Access Compliance Report

# Public Rights-of-Way
(Curb Ramps)

Intersection ID: N/A	Main Street: SAWMILL_RACE_DR	Cross Street: SILVERSWORD_DR	Location:	N
ADA ID: ACAE57992743	Ramp Type: Combination2Diag	Initial Pass/Fail: Fail	Overall Compliance: No	Severity Score: 0

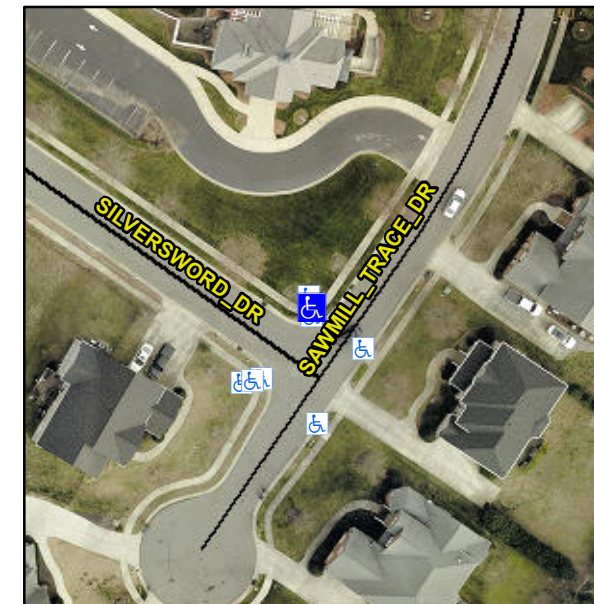
Not Found, R304.5.1, R304.5.3

Compliance	Description	Data	Compliance	Description	Data
N/A	Ramp Length LT (in)	7.0	N/A	Ramp Length RT (in)	7.0
Yes	Ramp Width LT (in)	48.0	No	Ramp Width RT (in)	47.0
Yes	Ramp Slope LT (%)	7.3	Yes	Ramp Slope RT (%)	2.2
Yes	Ramp XSlope LT (%)	1.5	Yes	Ramp XSlope RT (%)	1.3
N/A	Ramp Length (in)	49.0	Yes	Ramp Slope (%)	4.4
Yes	Ramp Width (in)	48.0	No	Ramp XSlope (%)	5.4
N/A	Flare Type LT	N/A	N/A	Flare Type RT	N/A
N/A	Flare Slope LT (%)	N/A	N/A	Flare Slope RT (%)	N/A
N/A	Flare Traversable LT?	N/A	N/A	Flare Traversable RT?	N/A
N/A	Landing Length (in)	N/A	N/A	DWS Provided?	N/A
N/A	Landing Width (in)	N/A	N/A	DWS Contrast?	N/A
N/A	Landing Slope (%)	N/A	N/A	DWS Length (in)	N/A
N/A	Landing X Slope (%)	N/A	N/A	DWS Full Width?	N/A
N/A	Landing Curb? (Y/N)	N/A	N/A	DWS Offset (in)	N/A
N/A	Shared Landing?	N/A			
N/A	Gutter Ponding?	N/A	N/A	Gutter Slope (%)	N/A
N/A	Gutter Lip Ht (in)	N/A	N/A	Gutter X Slope (%)	N/A
N/A	Painted X Walk1?	No	N/A	Painted X Walk2?	No

Remove & Replace Curb Ramp With Two New Directional Ramps or Equivalent.
